METROPOLITAN GOVERNMENT OF NASHVILLE AND DAVIDSON COUNTY

STAFF RECOMMENDATION 3715 Princeton Avenue November 19, 2014

Application: New construction-addition
District: Richland-West End Neighborhood Conservation Zoning Overlay
Council District: 24
Map and Parcel Number: 10405016200
Applicant: Preston Quirk
Project Lead: Paul Hoffman, paul.hoffman@nashville.gov

Description of Project: The proposal is for a single-story addition to the rear of the house.

Figure 3. Existing outbuilding. The rear wall of the addition will be sixteen feet (16') from this structure

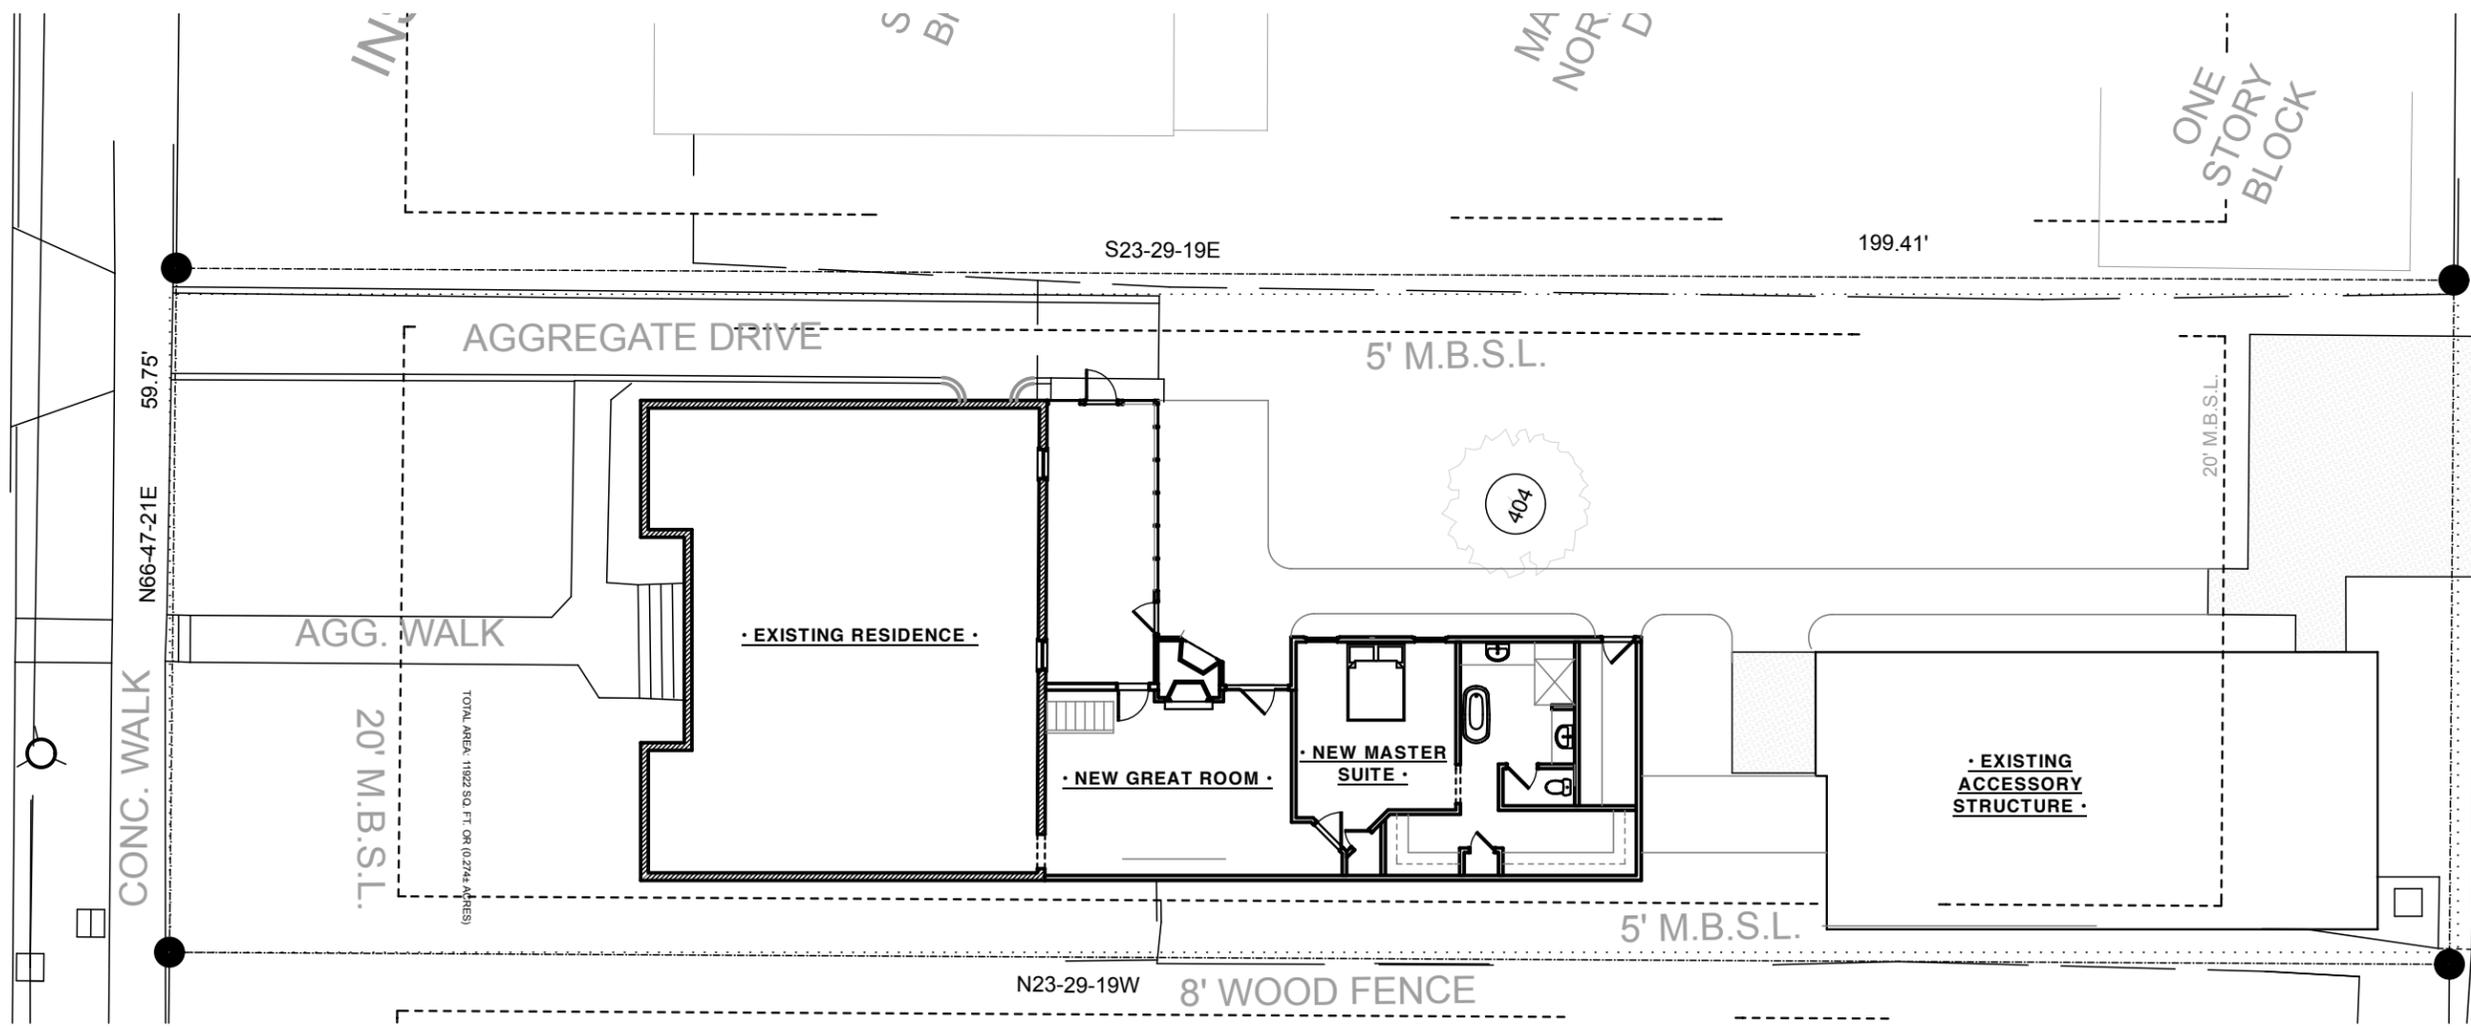
Proportion & Rhythm of Openings: No changes to the existing window or door openings of the original house are indicated. The rear wall of the existing rear addition will be removed (see Demolition). The proposed windows are generally twice as tall as they are wide, meeting the historic proportion of openings. There are expanses without openings on the west and south elevations of approximately thirty feet (30’) and twenty-one feet (21’) respectively; however, visibility of these locations is minimal, as they are facing a privacy fence and an existing outbuilding.

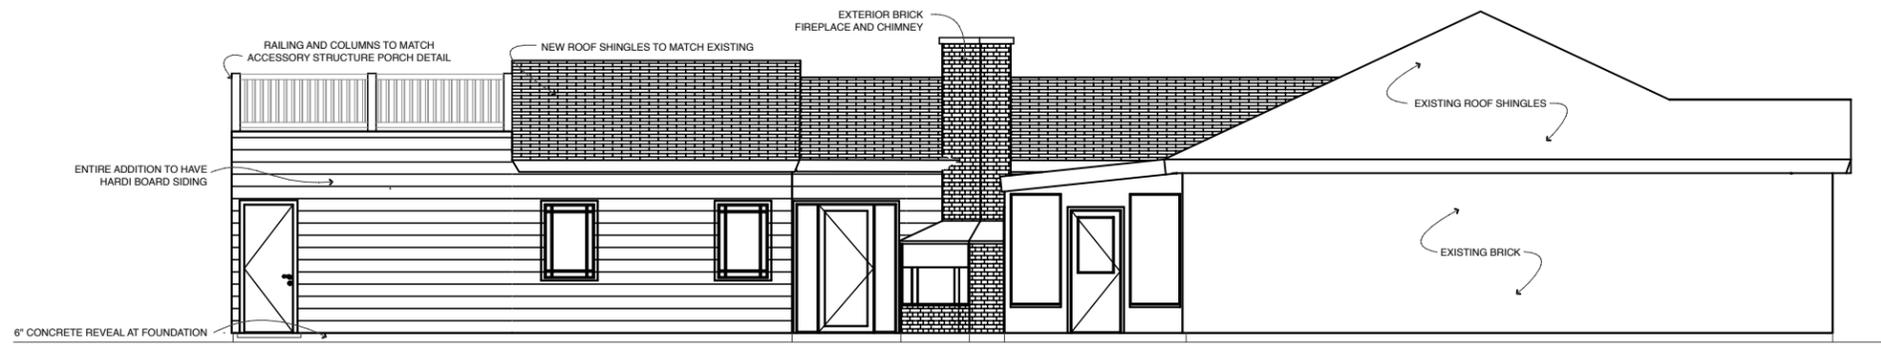
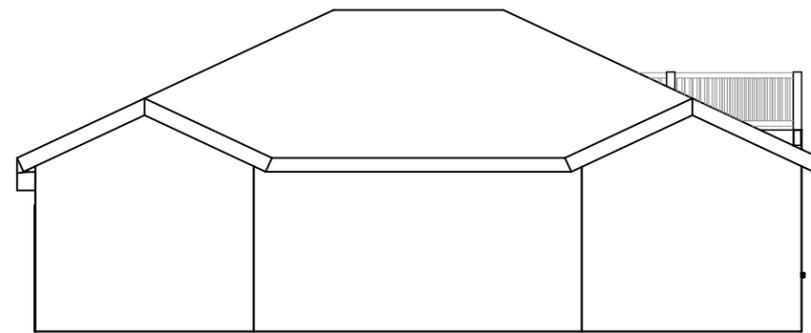
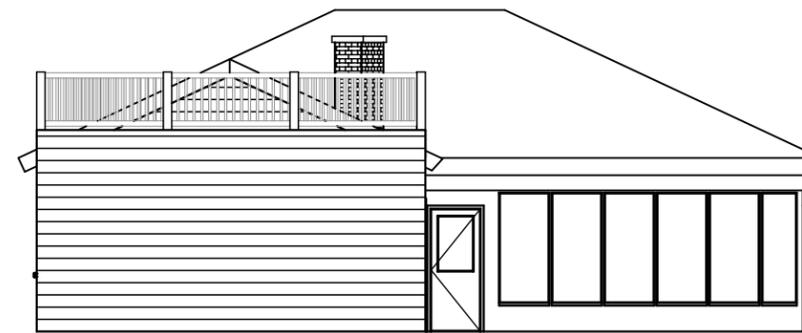
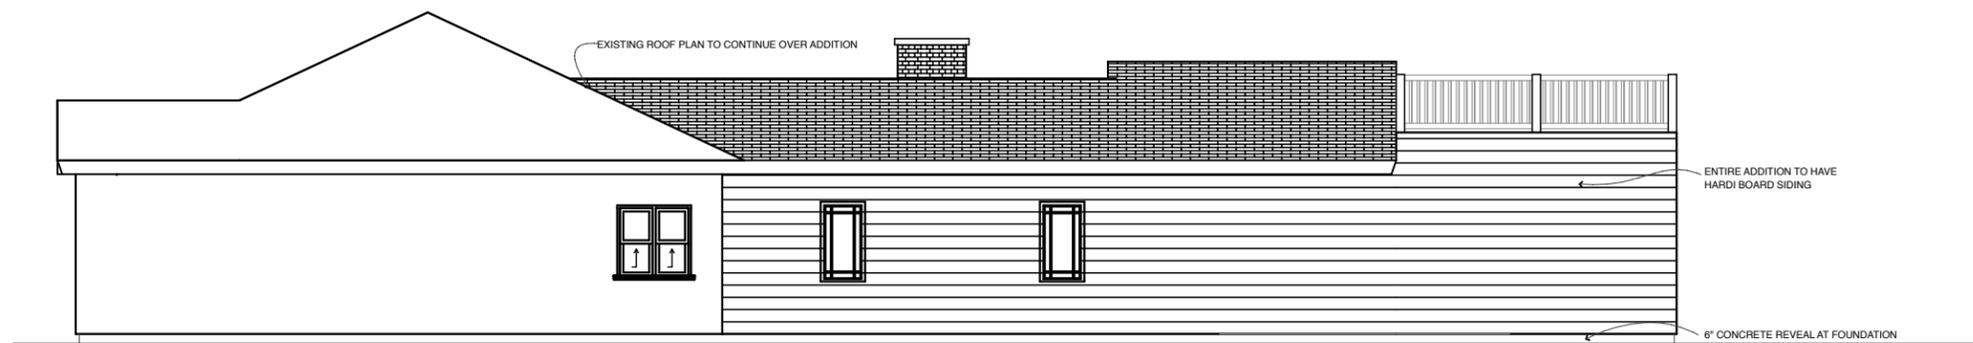
Height & Scale: The house is forty-two feet (42') wide and forty-five feet (45') deep. The addition will add forty-two feet (42') to the depth of the house and will be twenty-one feet, two inches (21'2") wide, approximately half the width of the house. Its maximum height will be fourteen feet (14') from grade, compared to the house's ridge height of eighteen feet (18'). Staff finds the addition's height and scale compatible with the context, and meet sections II.B.2.e and II.B.1.a and b.

Materials: The addition will be clad in smooth-face fiber cement siding; Staff requests the siding have a maximum reveal of five inches (5"). The foundation will be concrete block with six inches (6") revealed. No changes to the materials of the house are

indicated on the submitted drawings. With Staff approval of windows and doors, and the condition that the siding have no more than five inches (5”) of reveal, the project meets sections II.B.2.e and II.B.1.d for materials.

Roof Form: The addition will have a gabled form with 5/12 pitch. The rear of the addition has a rooftop deck, which is not common, but there are examples of it in this district. An exterior chimney will be built at the interior corner where the addition meets the existing screen porch. The roof form is compatible with the context. The project meets II.B.2.e and II.B.1.e

1. Staff approve windows and doors prior to purchase and installation;
2. Lap siding have a maximum reveal of five inches (5"); and,
3. HVAC and other utilities be located to minimize visibility from the street, if they are to be moved.
